**Placer County Office of Education**

HVAC Package Unit Replacement

**ADDENDUM NO. 1**

Tuesday, May 26, 2025

**A** DEMOLITION MECHANICAL ROOF PLAN  
SCALE: 3/32" = 1'-0"

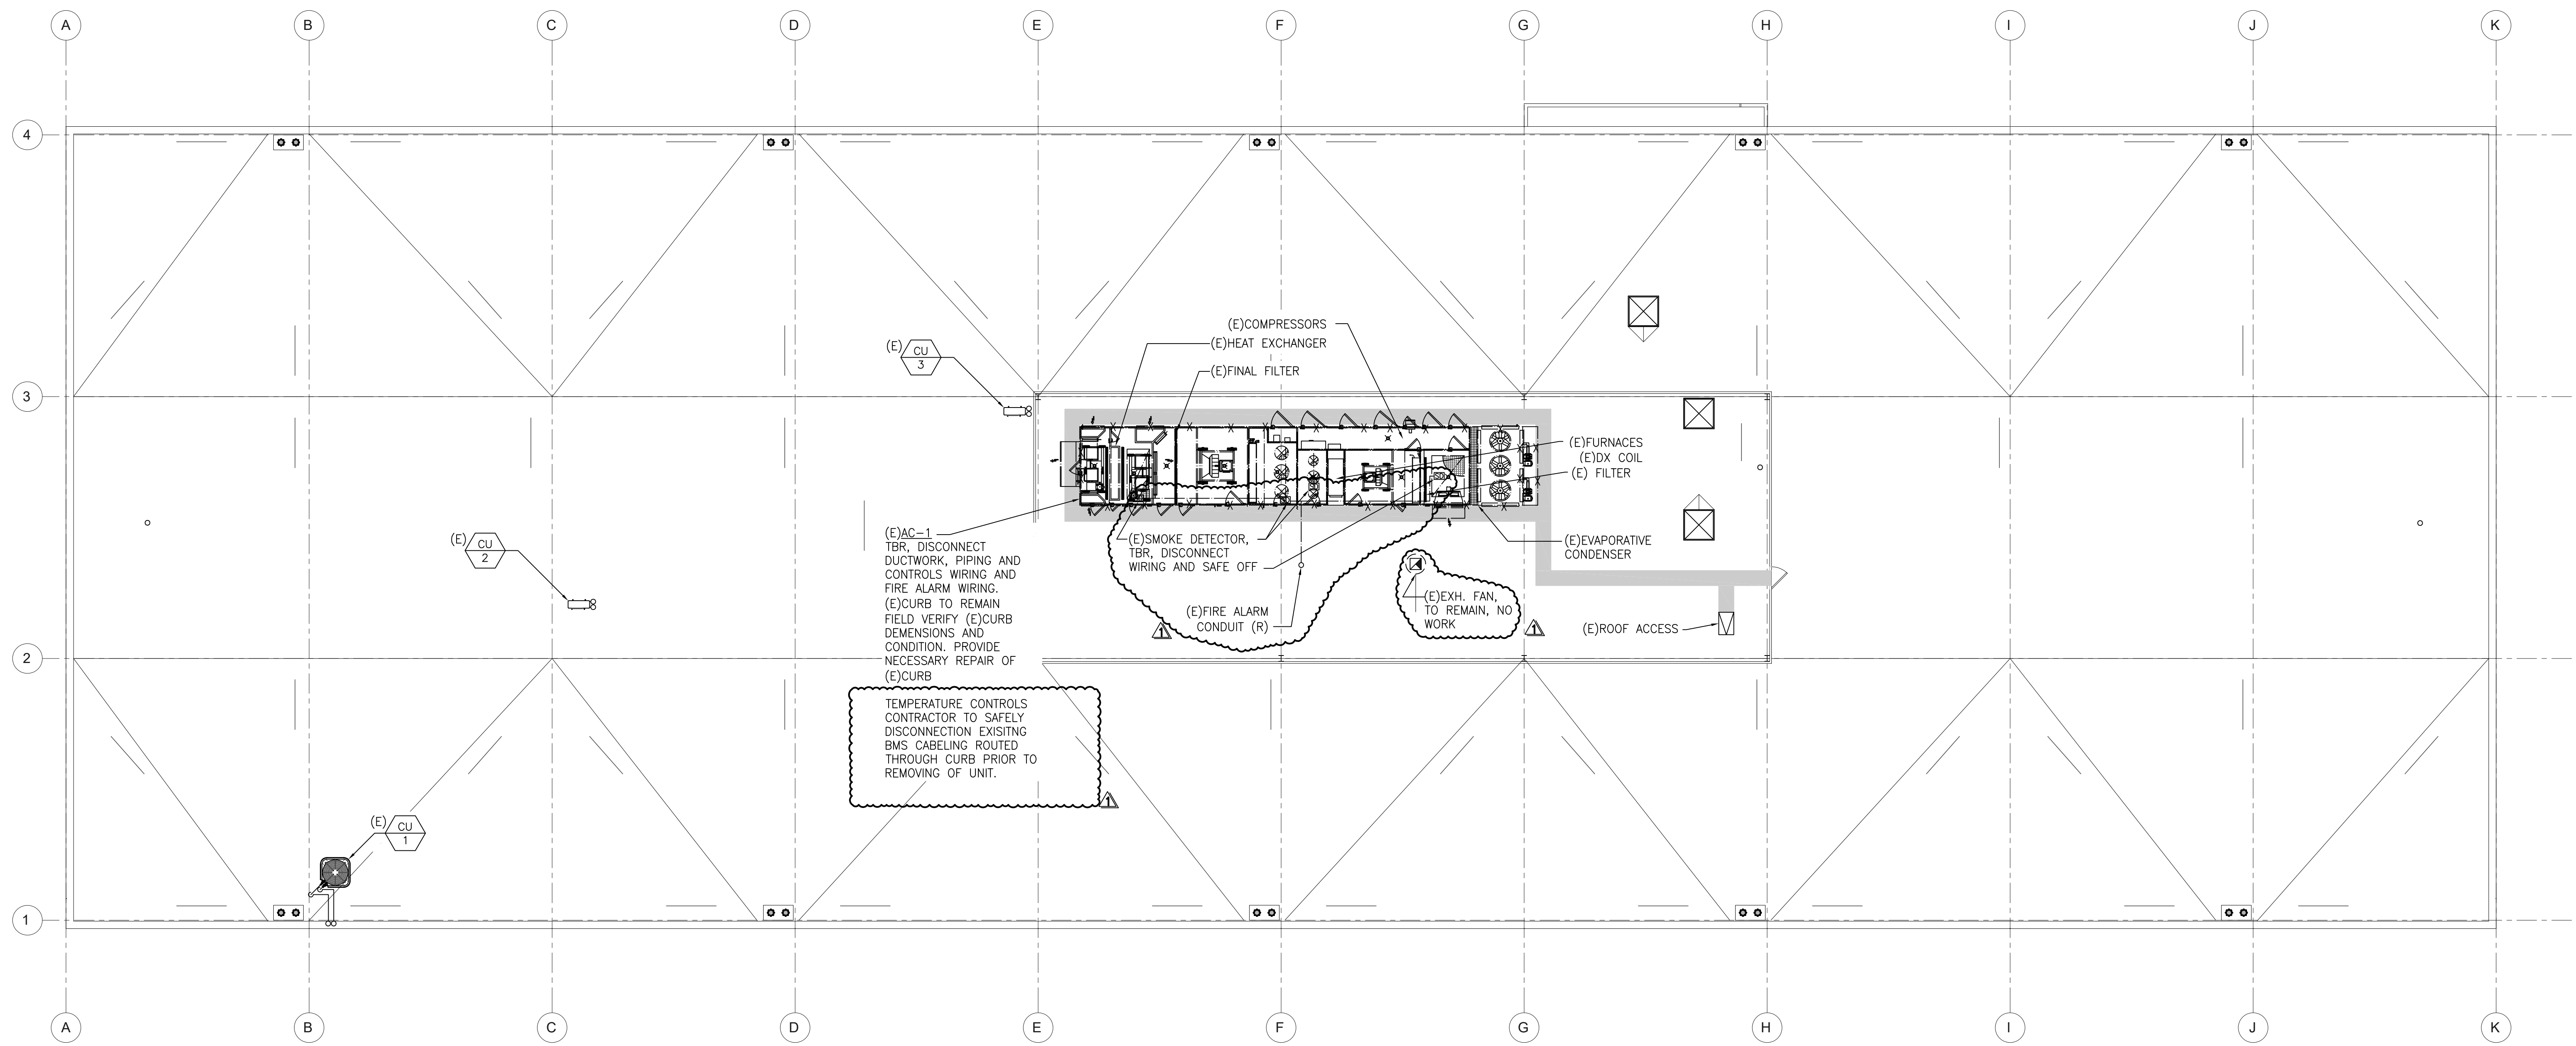
3. Sheet M3.11
  - a. **REVISE:** Detail A/M3.11 to show the existing exhaust fan.
  - b. **REVISE:** Detail A/M3.11 to show the existing fire alarm conduit and duct smoke detector locations within the unit that will need to be disconnected and removed.

- c. **REVISE:** Note for the controls contractor to safely disconnect existing controls cabling from BMS to unit through the existing curb prior to removal of the unit.

**B** EXISTING ROOF CURB & SLEEPER DETAIL — SHOWN FOR REFERENCE  
NO SCALE

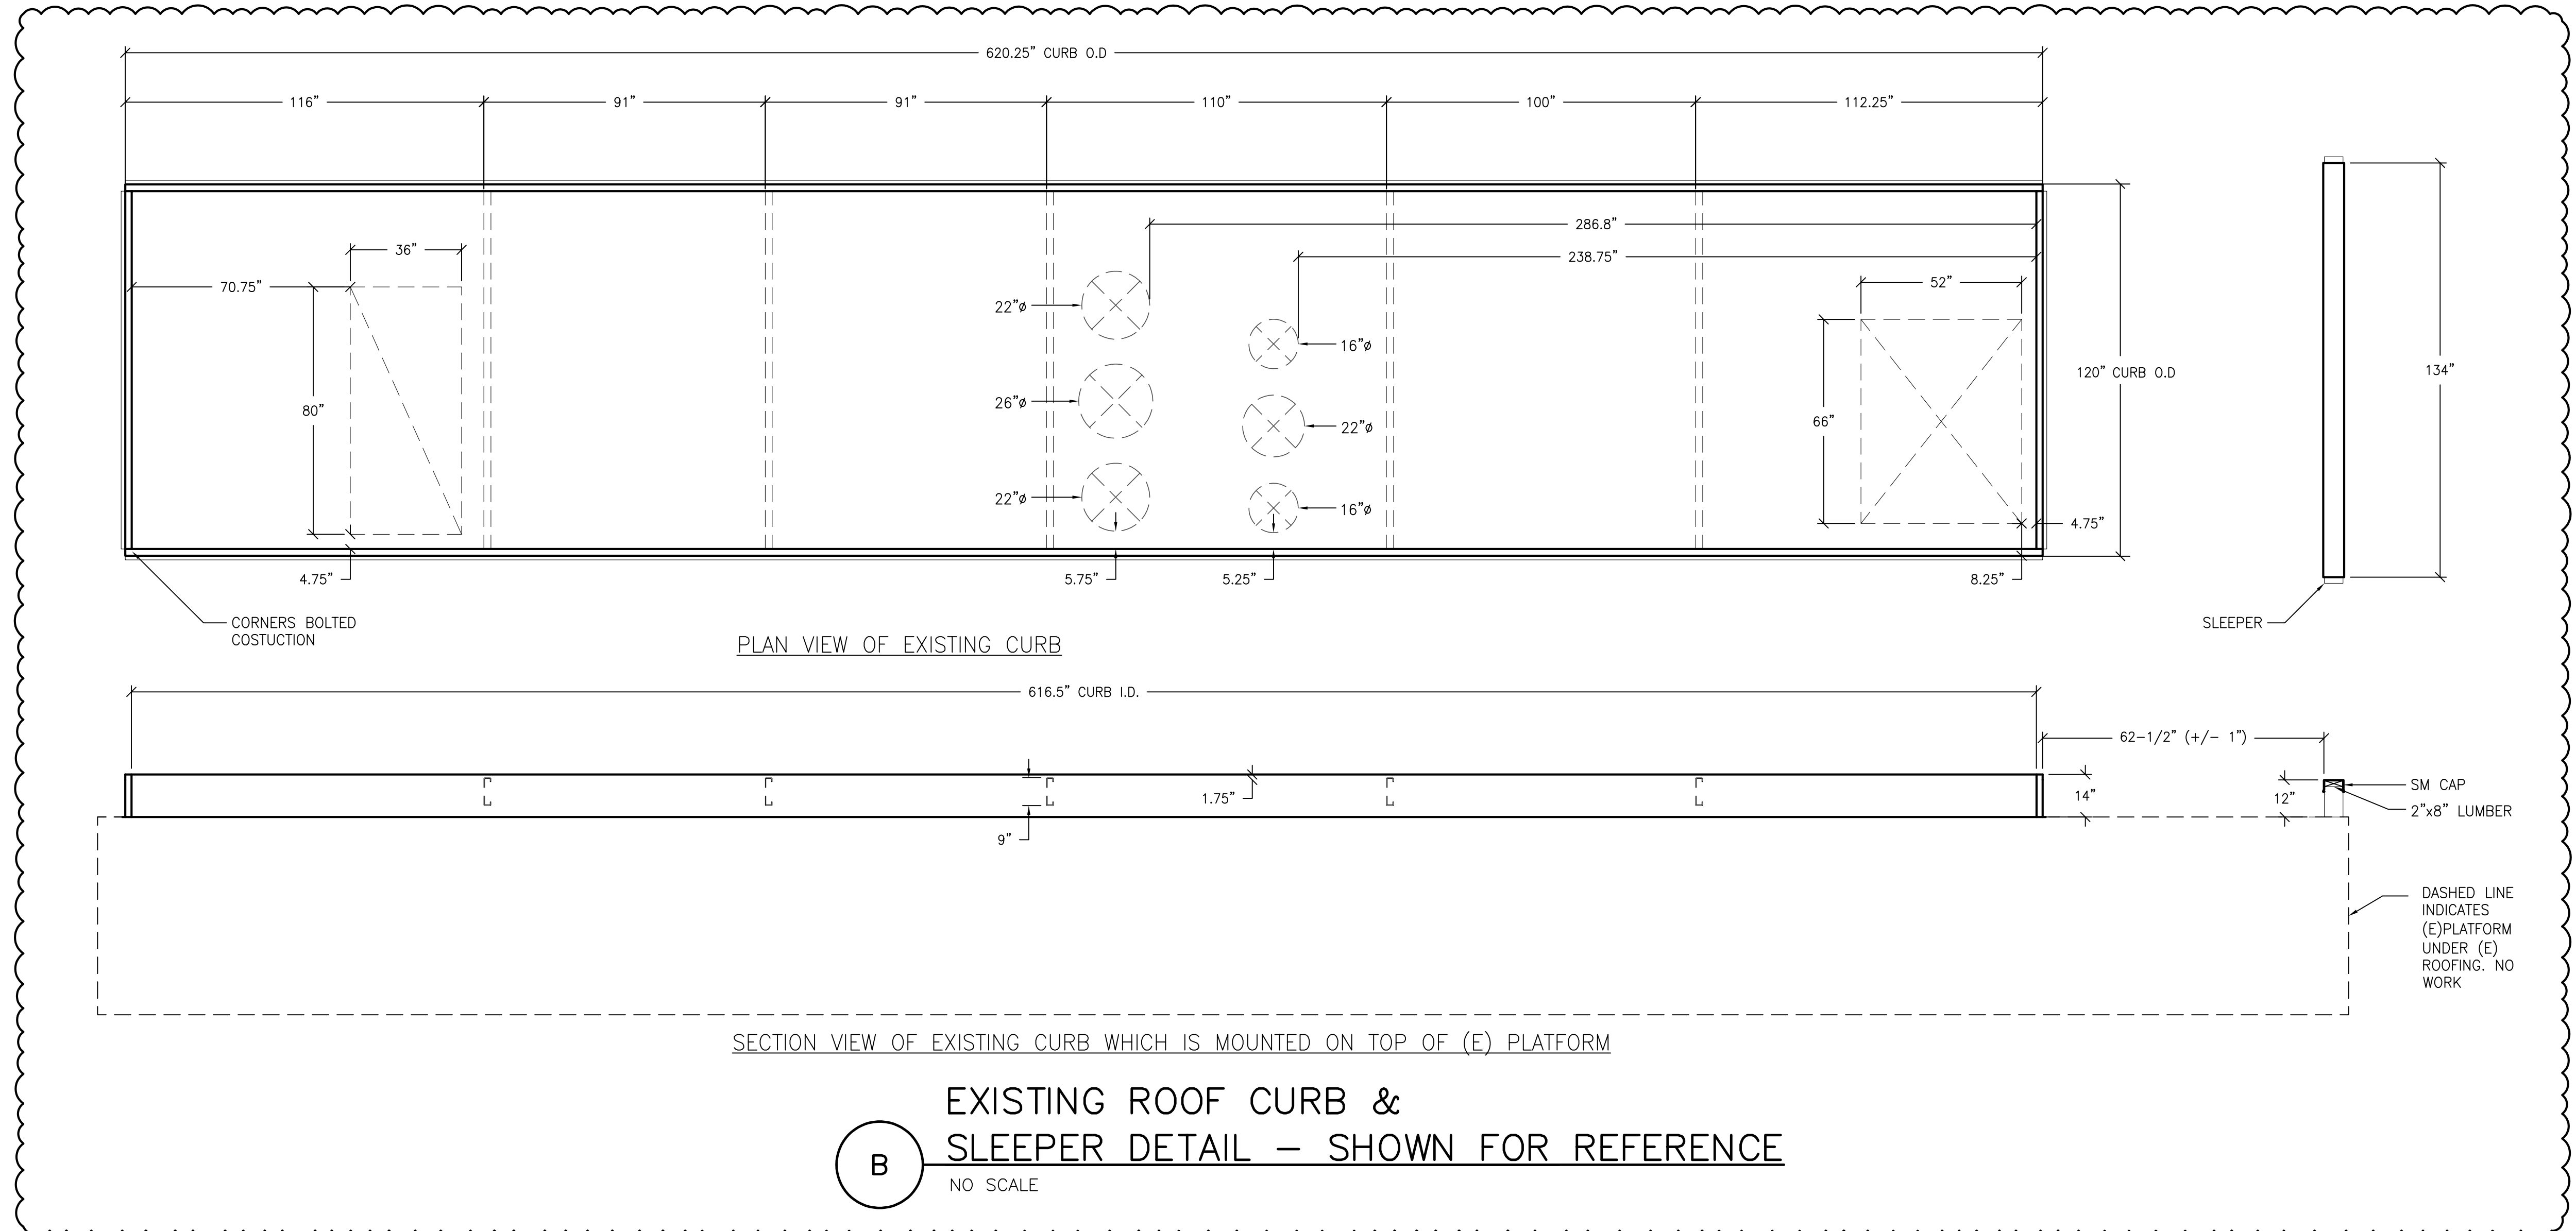
- d. **ADD:** Detail B/M3.11 to show the existing curb information available from the existing unit manufacturer; with the dimensions.
4. Sheet M3.21
  - a. **REVISE:** Detail A/M3.21 to show the existing exhaust fan.

**A MECHANICAL ROOF PLAN**  
SCALE: 3/32" = 1'-0"

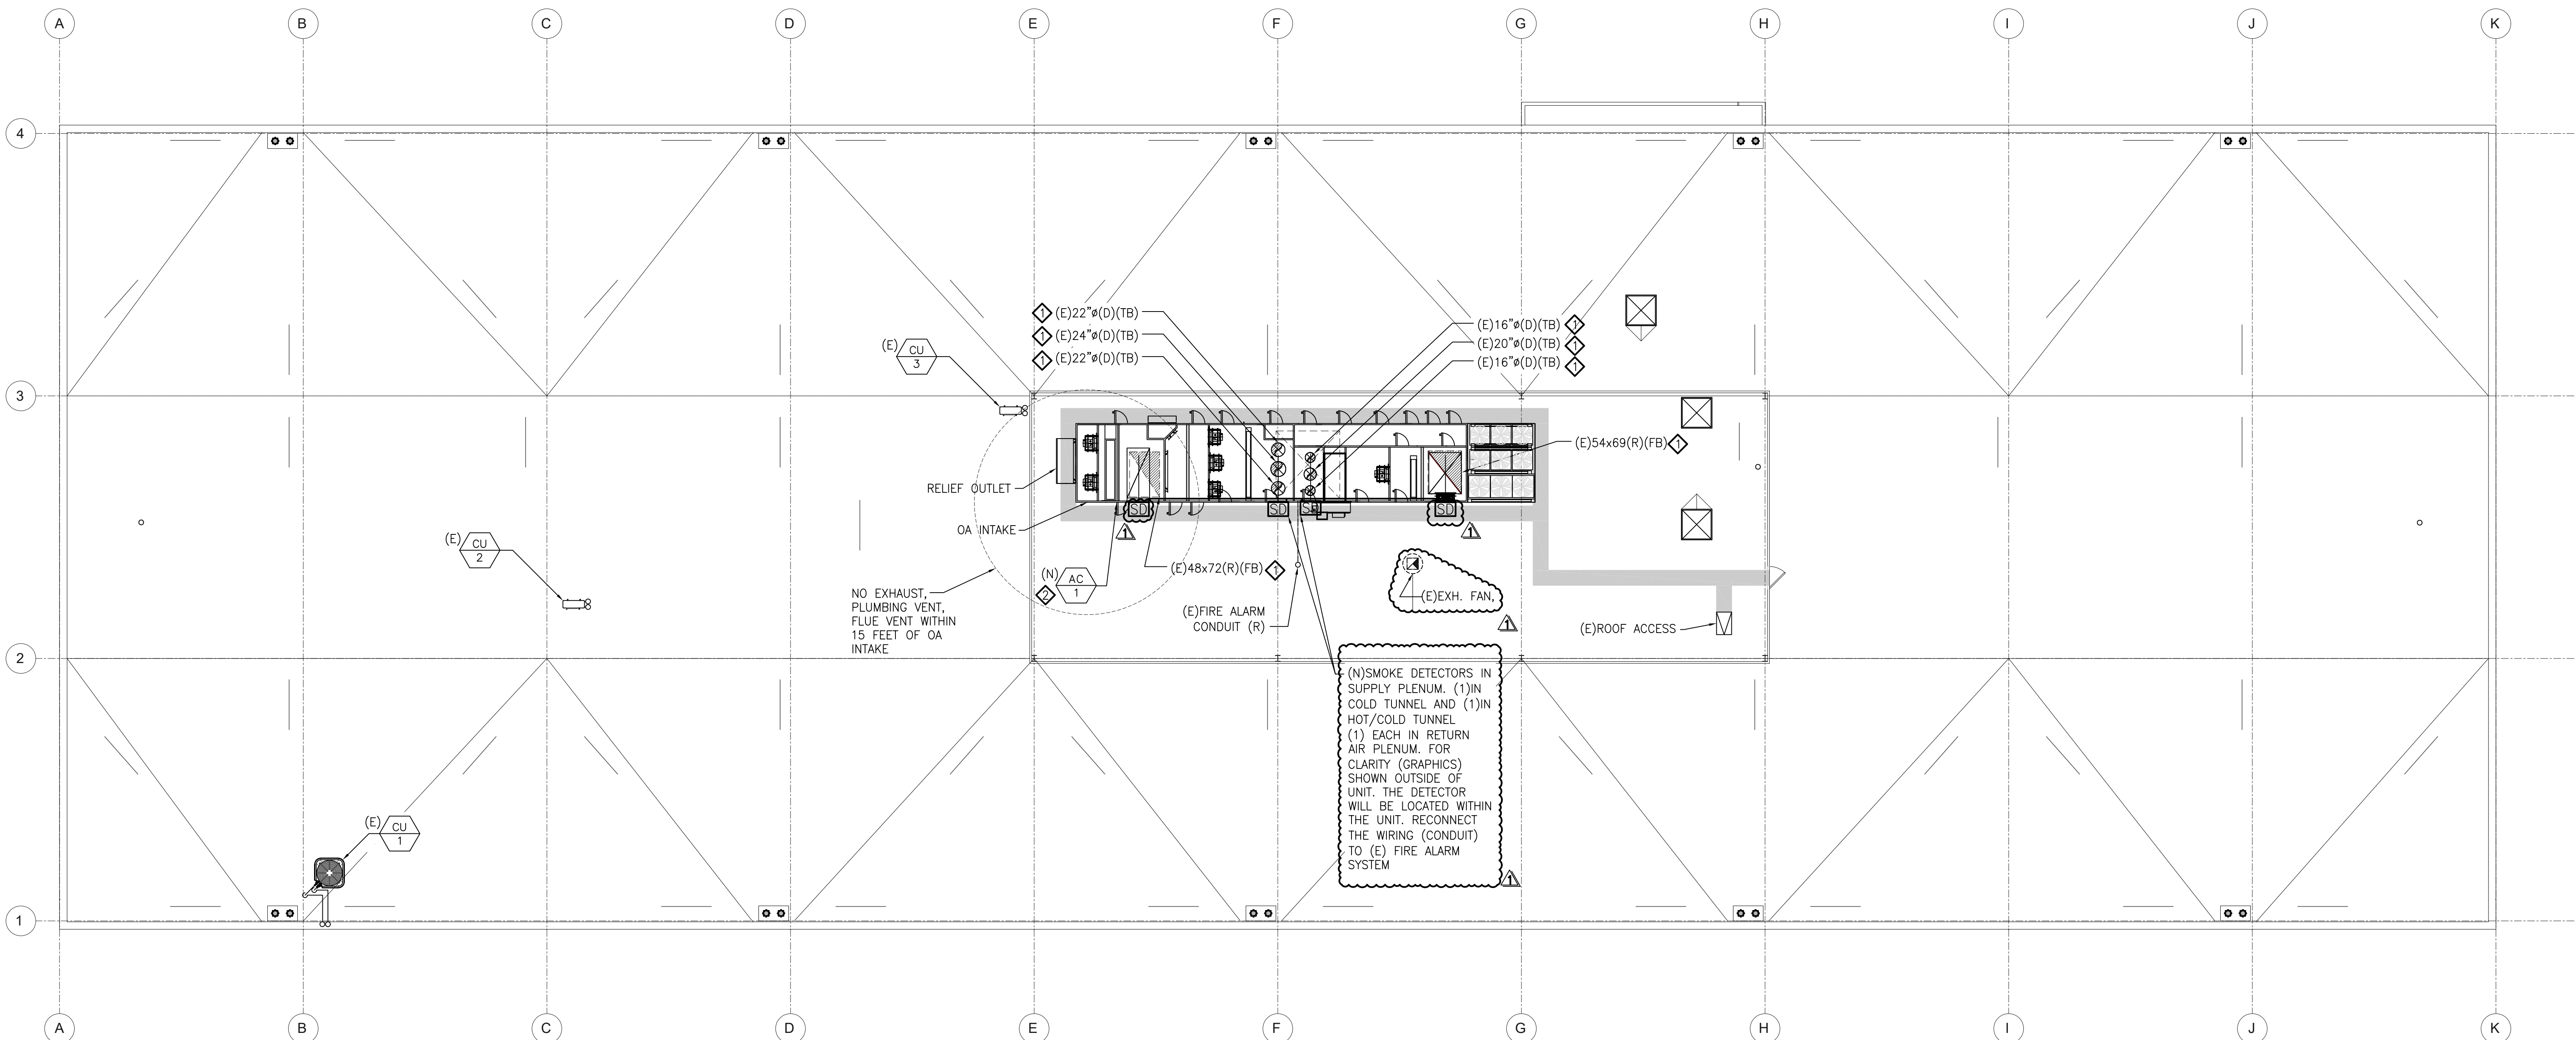
- b. **REVISE:** Detail A/M3.21 to clarify the duct smoke detector quantity and locations.
  - c. **ADD:** Detail B/M3.21 is added to clarify the intent of the unit support on the existing curb.

(N) SMOKE DETECTORS IN SUPPLY PLENUM, (1) IN COLD TUNNEL AND (1) IN HOT/COLD TUNNEL (1) EACH IN RETURN AIR PLENUM. FOR CLARITY (GRAPHICS) SHOWN OUTSIDE OF UNIT. THE DETECTOR WILL BE LOCATED WITHIN THE UNIT. RECONNECT THE WIRING (CONDUIT) TO (E) FIRE ALARM SYSTEM

**B** EQUIPMENT GAS CONNECTION DETAIL  
NO SCALE

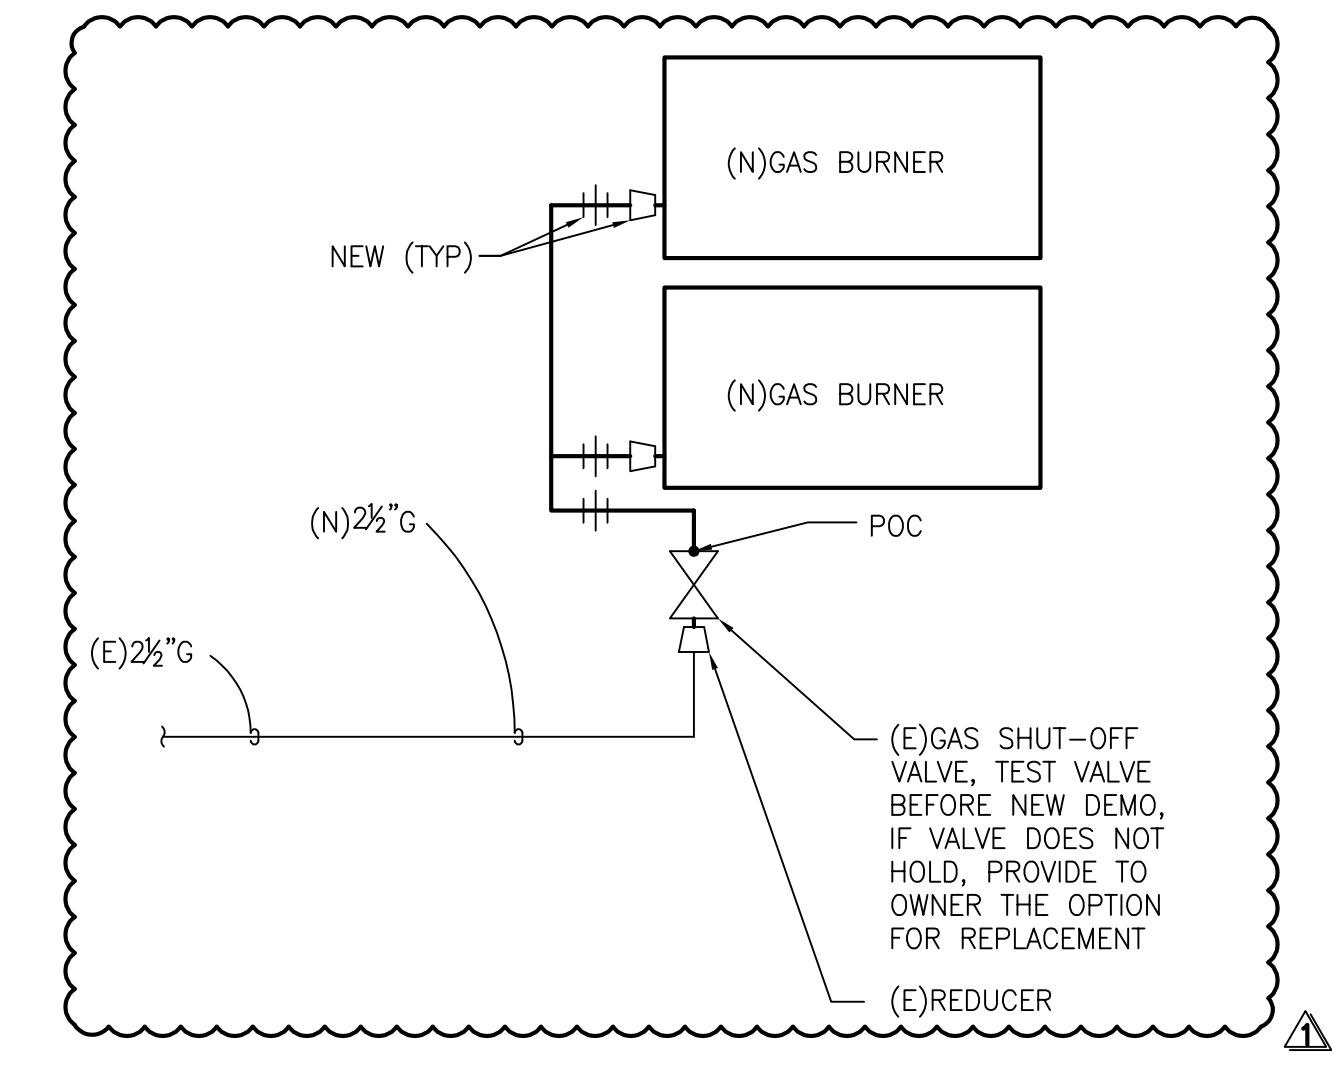
5. Sheet P0.01
  - a. **REVISE:** Piping Material Schedule to add gas piping material.
  - b. **REVISE:** Detail B/P0.01 for gas piping connection to the unit.
